TECHNICAL BULLETIN

TB-25-002

Title: Major Changes in New Version 4 of Assembly No. ASSY-1513 – Wildlife Protection Equipment

Assembly no. ASSY-1513 (V4) – Wildlife Protection Equipment

BIRD-FLIGHT DIVERTER (SEE NOTES 1, 2, 3, AND 4)

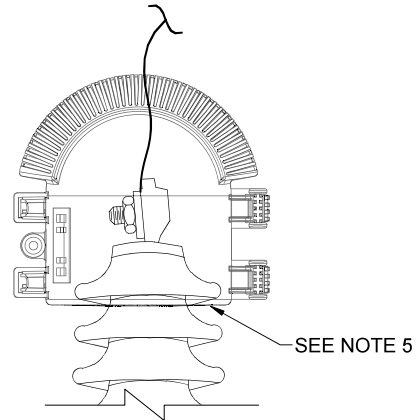
- A. A new air break switch guard (ABS) for wildlife protection (item 0209) has been added to provide enhanced protection for wildlife. It is designed to prevent wildlife from coming into contact with live electrical components.
- B. Modifications to drawings and notes for bird-flight diverters (item 0170) installation to clarify and ensure proper installation.
- C. Notes and details were added to the drawings for wildlife protection equipment to update and facilitate their installation.

1. BIRD-FLIGHT DIVERTERS (ITEM 0170) SHALL BE INSTALLED IN PROTECTED AREAS, SUCH AS BIRD SANCTUARIES.
2. BIRD-FLIGHT DIVERTERS (ITEM 0170) CAN BE INSTALLED BY HAND OR USING AN APPLICATOR RING TOOL (ITEM 0167) ON A UNIVERSAL HOT STICK AND A SHOTGUN STICK.

3. FOR VERTICAL CONSTRUCTION, BIRD-FLIGHT DIVERTERS (ITEM 0170) SHALL BE INSTALLED ON THE UPPER AND LOWER PHASE CONDUCTORS. THE INITIAL DIVERTER ON THE TOP CONDUCTOR SHALL BE OFFSET 15'-0" FROM THE POLE. THE INITIAL DIVERTER ON THE BOTTOM CONDUCTOR SHALL BE OFFSET 15'-0" FROM THE ONE ON THE UPPER CONDUCTOR. SUBSEQUENTLY, ON THE SAME PHASE CONDUCTOR, DIVERTERS SHALL BE PLACED 30'-0" APART.

4. FOR DELTA CONSTRUCTION, BIRD-FLIGHT DIVERTERS (ITEM 0170) SHALL BE INSTALLED ON ALL PHASE CONDUCTORS. THE INITIAL DIVERTER ON THE FIRST CONDUCTOR SHALL BE OFFSET 15'-0" FROM THE POLE AND MAINTAINING AN OFFSET OF 15'-0" BETWEEN THE DIVERTERS ON OTHER CONDUCTORS. SUBSEQUENTLY, ON THE SAME PHASE CONDUCTOR, DIVERTERS SHALL BE PLACED 30'-0" APART.
